February 13, 2019

**RE: Response to Comments (Biology) – Three Twins Vineyard Agricultural Erosion Control Plan Application File No. P18-00435-ECPA; 704 Greenfield Road, St. Helena, APN 025-380-017**

Photo 5: The tall snag near the eastern edge of the Project Area which may have potential to support bat roosting. Arrows indicate openings in the trunk.

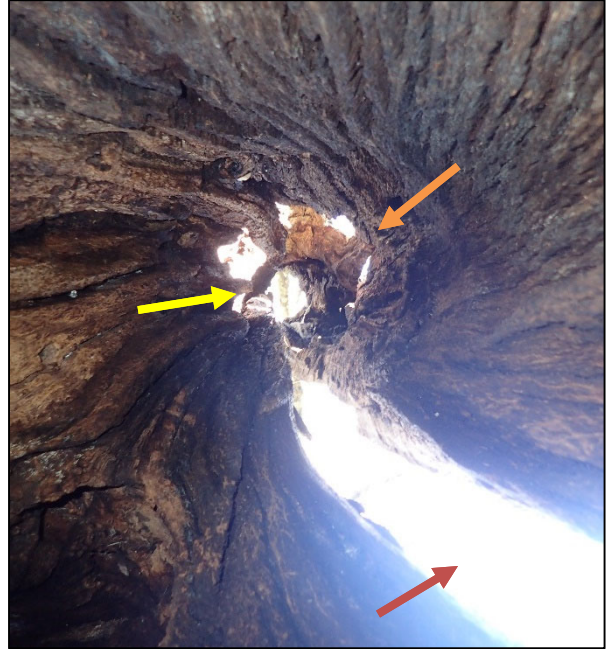
*iii. Section 5.2.2 indicates that the trees within the project area may contain habitat appropriate for a number of special-status bat species. Please include in the report an evaluation of the individual trees proposed for removal, and whether or not they specifically provide bat habitat.*

One large snag located in the eastern portion of the Project Area has the potential to support roosting bats. The snag has a large cavity which was investigated to the extent practical; however, there was no way to fully investigate the upper sections of the trunk which contained fissures and basal cavities that appear to be suitable for bat roosting. The snag is featured in Attachment B.

Because work to fell the snag is proposed to begin outside of the maternity season, and the snag appears to support suitable features for bat roosting we recommend the project proceed in the following fashion.

The snag should be removed outside of the maternity roosting season using a two-phase cut system described below.

- Day 1, Any surrounding trees should be removed, and any external limbs can also be removed. If any exfoliating bark has developed it may also be partially peeled off to cause disturbance to the snag.
- Day 2, The snag should be felled in sections and lowered to the ground under the observation of a bat biologist. The sections should be allowed to lie for 24 hours before being processed or off-hauled.
